Access Compliance Report

Public Rights-of-Way

(Curb Ramps)

Intersection ID: 7523	Main Street: COTTONWOOD_ST	Cross Street: N_GRAHAM_ST	Location: E
ADA ID: DFD05346A23A	Ramp Type: Para	Initial Pass/Fail: Pass	Overall Compliance: No
Codes/Mitigation Info/Possible Solution		Field Measurements/Component Compliance	
Severity Score: 2.75

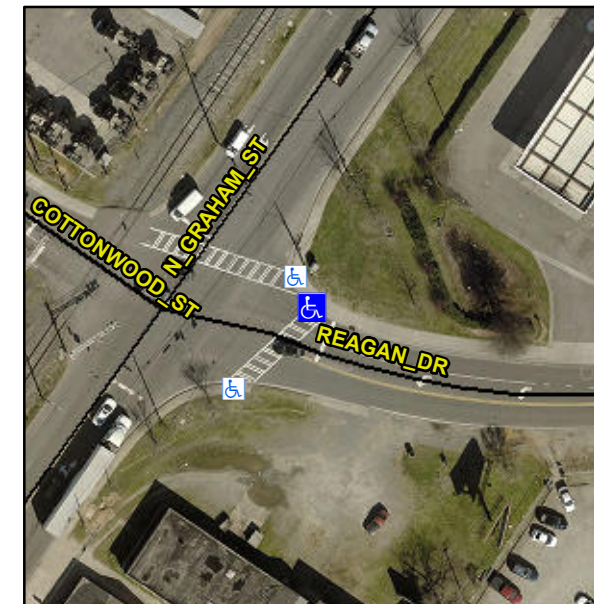
R304.5.3, R305.1.4, R305.2

Compliance	Description	Data	Compliance	Description	Data
N/A	Ramp Length LT (in)	63.5	N/A	Ramp Length RT (in)	66.0
Yes	Ramp Width LT (in)	71.0	Yes	Ramp Width RT (in)	72.0
Yes	Ramp Slope LT (%)	6.5	Yes	Ramp Slope RT (%)	5.4
No	Ramp XSlope LT (%)	2.6	Yes	Ramp XSlope RT (%)	1.8
Yes	Landing Length (in)	71.5	Yes	DWS Provided?	Yes
Yes	Landing Width (in)	50.5	Yes	DWS Contrast?	Yes
Yes	Landing Slope (%)	1.2	Yes	DWS Length (in)	24.0
Yes	Landing X Slope (%)	1.2	No	DWS Full Width?	No
N/A	Landing Curb? (Y/N)	No	No	DWS Offset (in)	3.0
N/A	Shared Landing?	No			
Yes	Gutter Ponding?	No	Yes	Gutter Slope (%)	1.5
Yes	Gutter Lip Ht (in)	0.0	Yes	Gutter X Slope (%)	0.8
N/A	Painted X Walk1?	No	N/A	Painted X Walk2?	N/A
	X Walk 1 Direction	To SW		X Walk 2 Direction	N/A
N/A	X Walk 1 Width (in)	N/A	N/A	X Walk 2 Width (in)	N/A
	X Walk 1 Slope (%)	3.8		X Walk 2 Slope (%)	N/A
	X Walk 1 X Slope (%)	1.9		X Walk 2 X Slope (%)	N/A
N/A	Ramp inside XWalk1?	N/A	N/A	Ramp inside XWalk2?	N/A

Remove & Replace Entire Ramp.
